# WATER QUALITY MEMORANDUM

## Utah Coal Regulatory Program

RE: First Quarter 2015 Water Monitoring, PacifiCorp, Deer Creek Mine.  
C/015/0018, Task ID #4832

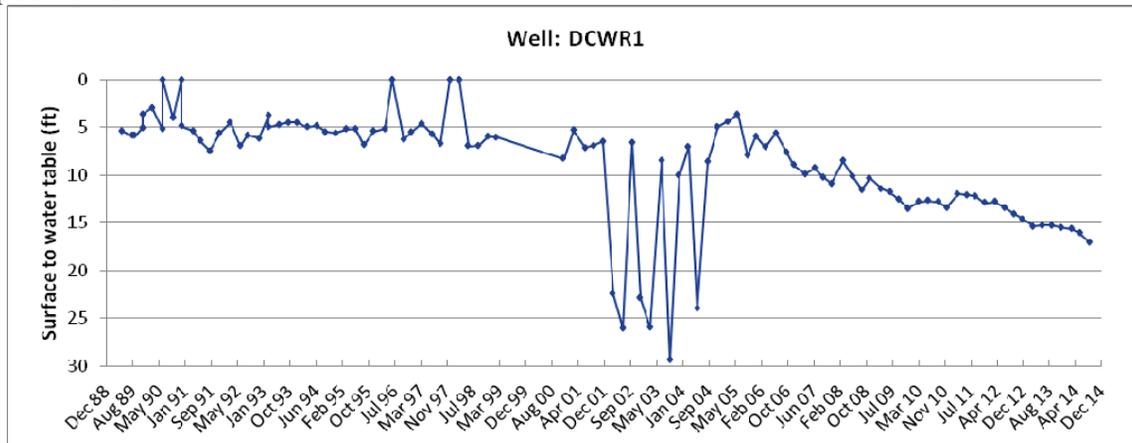
The water temperature at Main North Main East varies seasonally year-after-year (see following chart), indicating that this in-mine source is most likely fed by infiltrating surface water rather than draining surrounding strata. The temperature at TW-10 shows some seasonal variation, but it is not as definitive as at Main North Main East.
